Scoville Park Site Plan 2nd Questionnaire

Focusing only on the fencing, which of the following best describes your opinion of this element? (To view the schedule new window in your browser http://www.oakparkparks.com/NewsandInformation/FuturePlans/futureplans_scovillepa)

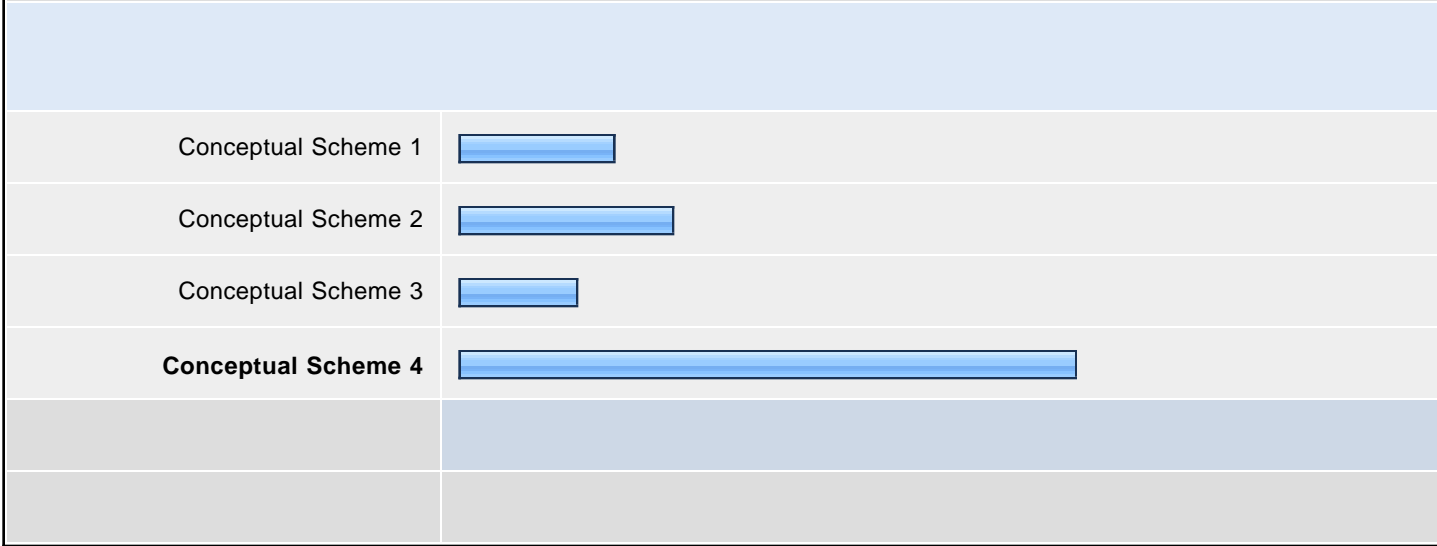
Response Text		
1	<p>It's a little hard to tell the difference between the 4 options, but it appears option 1 for the corner has more seating, which I like.</p> <p>In collaboration with the Village, we MUST get rid of the unsightly newspaper boxes at the corner, with a more aesthetically pleasing set of newspaper stands, similar to what the City of Chicago has done.</p> <p>The fountain upgrades must happen -- it is a wonderful entry piece to the corner.</p>	Apr 24, 2010 4:01 PM
2	more aesthetic	May 1, 2010 3:24 PM
3	It seems best-suited to serve people waiting for the bus	May 3, 2010 7:36 PM
4	I don't see much different between 1 and 2. I like the open circular design and as much seating as possible. That corner is used by people a lot; it's a good place to sit and wait, or meet people, or rest.	May 5, 2010 9:34 PM
5	more open space	May 5, 2010 9:55 PM

Response Text		
1	It appears to neaten up and expand the seating which I think is a very important element to retain; it keeps the fountain as the key feature and creates a welcoming opening without taking up much more room, as #4 appears to do.	Apr 25, 2010 8:05 PM
2	I like the curved seating around the open plaza with the fountain in the center. It is used like a plaza and with the new shape can act like one.	Apr 26, 2010 3:50 PM
3	Looks a little less cluttered. Hard to tell. Just don't like the bumpy bricks, stagnant fountain, and some of the people hanging out there.	May 1, 2010 1:37 AM
4	I like the curve seating, keeping the fountain and opening the space. It was a tough choice between number 2 and number 4 for this one. It looks like number 4 has some green around the fountain?	May 2, 2010 2:36 AM
5	I want to keep the old fountain, and I prefer the circular shape of scheme 2.	May 3, 2010 2:33 PM

6	Lesser of four evils. Siting the Horse Show Fountain in the middle of a flower bed doesn't make sense - it blocks people from getting close enough to examine the details and from using the fountain as a water fountain. However none of the other schemes seem to include any space for planters or flower beds. The entry path shouldn't be lined up directly behind the fountain. There's a more natural flow if the path is off center as it is now.	May 5, 2010 4:35 AM
7	it's bigger than in 1 or 3, and I don't like the grass around the fountain in 4 (I think it would be trampled to the point of death very quickly - impossible to maintain in such a trafficked area)	May 5, 2010 10:50 PM
8	Keeps fountain and seating.	May 6, 2010 2:00 PM

Response Text		
1	Entrance should be just that: an entrance, not a gathering space.	Apr 24, 2010 8:30 PM
2	Shape of the entry	Apr 27, 2010 9:21 PM
3	I like the sense of a semi-enclosed space around the fountain but with the option of sitting so as to view the park.	May 2, 2010 10:46 PM
4	clean lines, symmetrical and more formal than current. The brick collects litter and slightly unstable for seniors I'd guess.	May 6, 2010 4:11 AM

Response Text		
1	I think this scheme is the most inviting and decorative. The fountain is preserved in the center, and the addition of the planter adds color and draws focus towards the entrance.	Apr 23, 2010 8:16 PM
2	I like the greenery = but remember, cyclists meet at this space and we wouldn't want to endanger the plantings	Apr 23, 2010 9:53 PM
3	Keeps fountain, nice entry to park	Apr 24, 2010 3:20 PM
4	oval green space with surrounding paths seems welcoming	Apr 24, 2010 4:21 PM
5	The flower beds and the design creates a more welcoming feel than the others.	Apr 24, 2010 9:40 PM
6	Preserves and enhances the existing fountain area. Like seating there too.	Apr 24, 2010 11:24 PM
7	clean look	Apr 25, 2010 12:16 PM
8	Looks good	Apr 25, 2010 6:22 PM
9	flower beds???	Apr 25, 2010 6:53 PM
10	I prefer the orientation of the seating best.	Apr 26, 2010 2:16 PM
11	Minimizes disturbance to fountain. Great place to plant flowers; walls create great place to sit without the "benches" look; seems the most open and inviting.	Apr 26, 2010 2:32 PM

12	Itm opens up and defines the entrance, while creating its own central focal point as well.	Apr 26, 2010 5:17 PM
13	Love the green/flowers	Apr 27, 2010 2:50 PM
14	More green space	Apr 27, 2010 6:05 PM
15	Again, it has an inviting feeling to it. There seems to be more flow from the street into the park.	Apr 27, 2010 6:10 PM
16	Very open sightline to the park; connection to new loop path.	Apr 27, 2010 6:45 PM
17	Bump outs with the new entrance plaza and the new pathway	Apr 28, 2010 6:33 PM
18	I prefer what seems to be a more open layout of entrance.	Apr 29, 2010 4:57 AM
19	It appears to be the most open design	Apr 29, 2010 7:25 PM
20	looks like it would be more inviting	May 1, 2010 2:08 AM
21	Having all three corner entrances featuring a plaza with natural, historic, or artistic features gives greater coherence to the overall plan.	May 4, 2010 6:00 PM
22	I like the way Scheme 4 opens the area to the park and provides plenty of seating.	May 5, 2010 9:34 PM

23	Simple, has planting, opens easilly into park	May 5, 2010 10:05 PM
24	I like what I perceive as the openness and room for attractive landscaping.	May 5, 2010 10:22 PM
25	It is open.	May 5, 2010 11:55 PM

Response Text		
1	Keep lots of seating - maybe a community bulletin board?	Apr 23, 2010 9:53 PM
2	Perhaps a message board closer to the sidewalk, which would allow for posters to be placed in regards to upcoming Avenue District events, concert schedules for the park, art festivals, etc. Vs. hanging a big banner at the corner, which takes away from the aesthetics.	Apr 24, 2010 4:02 PM
3	Keep the fountain. Place more trash cans and empty them more frequently at all the entrances to the park and within the park. At each concert have someone talk to the crowd about the zero trash impact goal, and to leave the park cleaner than it was. It can be done. Jason Lofgren did it at an OP ball park.	Apr 24, 2010 8:33 PM
4	no	Apr 25, 2010 12:16 PM
5	No	Apr 25, 2010 6:22 PM
6	Work with the Village to move the newspaper stands west on Lake to allow for the proposed bigger entrance.	Apr 26, 2010 2:33 PM
7	It would be great to get water running through the Horse Show Fountain again.	Apr 26, 2010 3:51 PM

8	Schemes 1-3 lappear to limit or crowd the access to the park, but 1 or 2 could be made to work with a wider park opening in the seat walls.	Apr 26, 2010 5:20 PM
9	Putting the "fountain" in the center planting will forever eliminate the confusion as to it's unfilled purpose as a drinking fountain.	Apr 27, 2010 6:46 PM
10	no	Apr 29, 2010 7:25 PM
11	Just make it easy to get up on the path. Don't care about fountain. Want to be sure there aren't places where pedestrians can be ambushed at night.	May 1, 2010 1:38 AM
12	The brick definitely needs to be removed or smoothed out.	May 2, 2010 2:37 AM
13	Again, I don't see that any of the schemes are much of an improvement on the existing space.	May 2, 2010 10:46 PM
14	I believe the southeast corner should provide more shelter for persons waiting for a bus - simple roofs over the flanking benches would do the trick using, perhaps, cedar uprights to support the roofs - no side walls necessary.	May 4, 2010 6:02 PM

15	I don't think any of the four Conceptual Schemes works much better than what is already there. It would be nice if the seating and planters could reflect a FLW design aesthetic, in keeping with the Horse Fountain. I think the stone benches that are there now do that even though the material is a bit dated. Could the bottom part of the fountain be restored to creating a working fountain?	May 5, 2010 4:35 AM
16	I think opening the area more to the park might reduce the area's bus stop feel.	May 5, 2010 9:35 PM
17	Today's plaza is a very poor introduction to Scoville. It should be one of our best spaces	May 5, 2010 10:05 PM
18	seating is beneficial for the many who wait for busses	May 5, 2010 10:50 PM

Response Text		
19	Yes. I love the bit tighter shape and seat walls. Currently walls are oriented to the streets. Scheme 3 is a 'contained' plaza with facing seat walls. One at the corner providing sense of a 'gate' Love it.	May 6, 2010 4:16 AM
20	No	May 6, 2010 2:00 PM

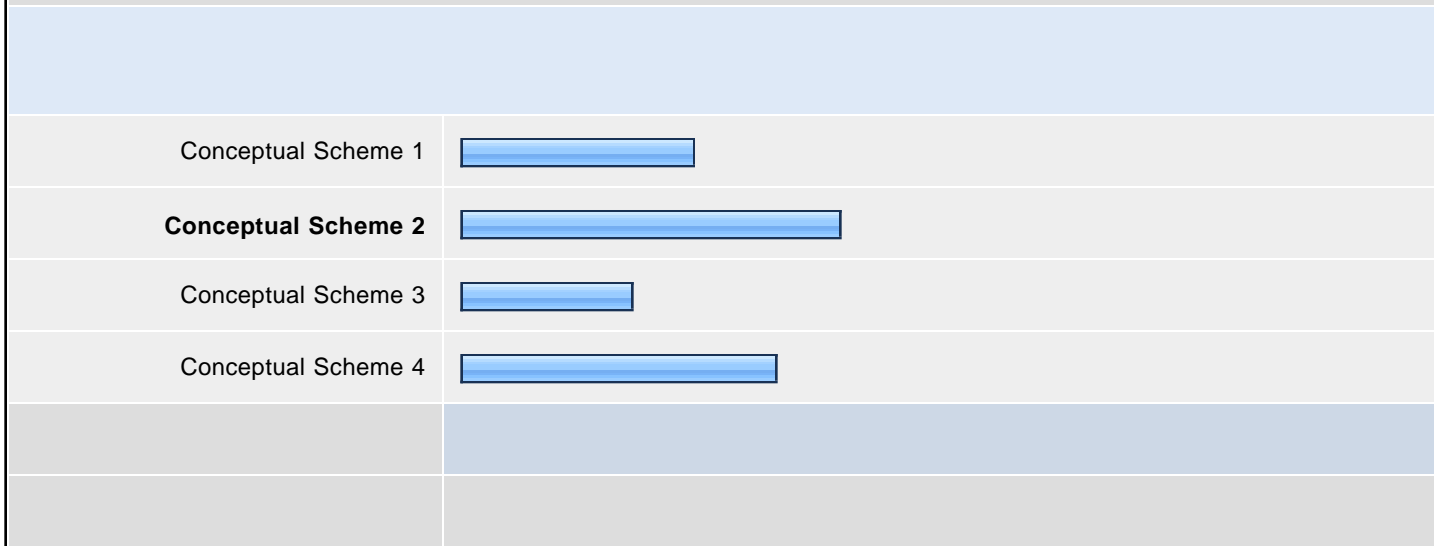
Response Text		
1	leaves 3 tennis courts and updates restrooms	Apr 24, 2010 4:25 PM
2	restroom addition	Apr 24, 2010 9:47 PM
3	Retains 3 tennis courts. The existing court are sloped and drain very well afer a rain. Please consider this in re-doing the courts. (Scheme 4 also retains the 3 courts.)	Apr 25, 2010 5:13 PM
4	Tennis is fine.	Apr 27, 2010 6:10 PM
5	It would keep one of the few lighted tennis courts in Oak Park. The Park District removed lighted courts when Stevenson Park was redone.	May 2, 2010 2:01 PM
6	leave 3 tennis courts. That is the only concern I have	May 3, 2010 12:44 AM
7	If people are complaining that there isn't enough tennis space, then taking away one court is not a good idea.	May 3, 2010 7:38 PM
8	All 3 tennis courts should be retained. These are the only 3 Park District tennis courts in central Oak Park, and they are used regularly by local residents. I don't like new paths in #2 and #4 because they would divide up the open space in the NE corner and make it less usable.	May 5, 2010 4:50 AM

Response Text		
1	Gives an entrance on north end. addresses desire lines	Apr 24, 2010 3:23 PM
2	Love the new entry plaza @ OP Ave, and walkways.	Apr 24, 2010 4:04 PM
3	Allows more roon for the park. Tennis is popular but Oak Park does not have enough green space.	Apr 24, 2010 4:06 PM
4	I like restoring the north end back to 2 courts and providing more open space in the corner. I picked scheme 2 over scheme 3 merely because it provided a path connection to the corner.	Apr 26, 2010 4:03 PM
5	I like the expanded playground area, the additional seating east of the courts, I like reducing the courts to 2 and adding another open space for people to use.	Apr 26, 2010 5:27 PM
6	It establishes a defined entry plaza at Ontario and Oak Park, creates more open spsce in the NE corner.	Apr 26, 2010 5:40 PM
7	Provides for new open lawn space to the right.	Apr 27, 2010 6:50 PM
8	I live across the street from the park, and note that the tennis courts are seldom all in use. I think reducing to two courts and increasing green space is a good idea.	Apr 29, 2010 2:23 AM

9	More space for 2-5 yr playground, which gets way more use than tennis courts. Please remove all courts and expand playground. Please replace sand with rubber or wood chips and cover for shade. Thanks!	May 1, 2010 1:56 AM
10	I like having more meadow/green space	May 1, 2010 2:09 AM
11	I am torn between 2 and 3 on this one actually. I think that one court should be removed. I like that concept 2 has a path down ontario leading to the park. I think that is important especially looking at the desire lines. From a practical standpoint I like the additional paths proposed (new loop path) but from a beauty standpoint, I like the green space of concept 3. I personally would use the new loop path often in concept 2 because I usually enter the park from Ontario, but it could be 'over-pathed.'	May 2, 2010 2:45 AM
12	We have plenty of tennis courts in this area, with the highschooll being right down the street. I live right here, the playground gets more use than the tennis courts. Lets give the kids the playground this area deserves. We do need add a better crosswalk over Oak Park avenue on the northern end of the park though.	May 3, 2010 2:42 PM

13	I like the reduced number of tennis courts and the increased number of pathways.	May 5, 2010 9:40 PM
14	Gets rid of the fence that today is in the way of views across the park and it gives us a new space	May 5, 2010 10:12 PM
15	I like the idea of a "scenic" path within the park. I'd be happy to trade a tennis court for open space if there's not an outcry from tennis players. I like the idea of a welcoming entrance at the NE corner of the park.	May 5, 2010 10:31 PM
16	because there's less tennis courts and the play lot seems bigger	May 5, 2010 11:01 PM

Response Text		
1	Creates a walkway inside the park along the north side.	Apr 24, 2010 8:37 PM
2	Do not see the need for three courts and I like expanding the lawn space	Apr 28, 2010 6:38 PM
3	Keep 2 tennis courts, but provide more lawn space to make better use. I only ever see two being used at any one time anyway.	Apr 29, 2010 5:00 AM
4	Enlarges / creates usable open space on north side.	May 6, 2010 4:22 AM

Response Text		
1	I am torn, but this scheme retains the third court while still opening up the north eastern entry to the park.	Apr 23, 2010 8:28 PM
2	preserves all existing courts, which receive plenty of use and are needed, and enhances NE corner	Apr 24, 2010 4:18 AM
3	Keep 3 courts!!!!!! These are highly used courts because they are central to the village, alternatives to busy HS courts, and near denser (condo and apt) areas of the village.	Apr 24, 2010 11:26 PM
4	It provides for better use of the park. There are limited tennis courts in Oak Park.	Apr 25, 2010 12:19 PM
5	i am TOTALLY against taking out a tennis court. we need MORE tennis courts in this town-not less. the park has enough open areas. don't lose a court. PLEASE!!!!!!	Apr 25, 2010 6:57 PM
6	It establishes a defined entrance at Ontario/Oak Park and supports a useful path syste, though I'm not certain the additional path access off of Oak Park is needed.	Apr 26, 2010 5:36 PM

7	Tearing down the courts would be an unnecessary expense, and why do it if they're in use? The playground is big enough; let's give the older kids and adults some play-places too. I also like having part of the trail away from the road in CS4, as opposed to CS1. It's a safer, more cozy feeling.	Apr 27, 2010 2:55 PM
8	There is a dearth of lighted tennis courts in the village. We need to retain the current three courts at Scoville.	May 2, 2010 3:11 PM
9	The only one that's different seems to be 3. I like the idea of the path on the north side, and the curved one in 1, 2, and 4 seems pleasing.	May 2, 2010 10:54 PM
10	I prefer 3 tennis courts - the entrance plaza similar to those at other corners - a meandering path along Ontario St.	May 4, 2010 6:12 PM
11	Retains all 3 lighted tennis courts.	May 6, 2010 2:04 PM

Response Text		
1	Scheme 2 is nice also because of the little bit of opening of the northeast entry except one of the courts is removed of course and I actually sat in my car and tried to picture the new circular path created by the removal of the court; it would seem to be a little congested or 'busy' even with that court removed.	Apr 23, 2010 8:31 PM
2	Work with the transportation dep't and get better signage and enforcement at the corner of Oak Park Avenue and Ontario for pedestrians. Cars are NOT stopping for pedestrians as they should. It is adangerous intersection for both autos and walkers.	Apr 24, 2010 8:40 PM
3	no	Apr 25, 2010 12:20 PM
4	no	Apr 26, 2010 5:27 PM
5	I do not like the circulation paths in the NE quadrant in Scheme 2 because they occupy too much of the open space this creates. I prefer the path and plaza structure of Scheme 4.	Apr 26, 2010 5:43 PM
6	I'd like the path from the NE corner, and not from the N end of the east side. So subtract the NE part of scheme 1 from the NE part of scheme 4. The most common path people would take as a shortcut across the park would be from the NE corner to the SW corner, and this should be more or less direct to minimize desire paths.	Apr 27, 2010 6:13 PM

7	Please remove all tennis courts. Playground gets used a lot more than tennis courts. Please remove sand and replace with rubber or wood chips. If rubber, please shade so it doesn't get so hot in summer. Thanks.	May 1, 2010 1:58 AM
8	While I think the bump outs are great- what really must happen is a yield by law pedestrian crossing. Cars drive entirely too fast down Oak Park Ave, hardly anyone stops for pedestrians (even police!!!) and it is very dangerous, especially with children. With the updated park, I think this is a must!! Today in fact some tourists were waiting to cross and eventually just walked on the sidewalk to the light (looked like they were going to the Hemingway Museum) things like this should not happen. And perhaps they decided then not to go to the museum? That means lost revenue- and I would venture to guess this is not the first time it happened. Anyways- I am very passionate about the additional to this yield for pedestrian crossing. I hope that can happen!	May 2, 2010 2:49 AM

9	The entrance plaza should somehow incorporate the continental divide information now contained on an impermanent sign. Tennis courts get more use than adjacent (eastward) park area which is hardly used at all but still offers plenty of space for picnics or just watching a tennis games	May 4, 2010 6:15 PM
10	A straighter path/sidewalk along Ontario would be preferable, if the grade and current trees would permit that.	May 5, 2010 4:52 AM
11	more oopen space	May 5, 2010 9:57 PM
12	Underutilized now and could be a neighborhood space.	May 5, 2010 10:12 PM

Response Text		
13	The current layout gives sense that the 'park' is only down in front and under the monument. This scheme unifies the park.	May 6, 2010 4:24 AM
14	Scheme 1 would also be good.	May 6, 2010 2:04 PM
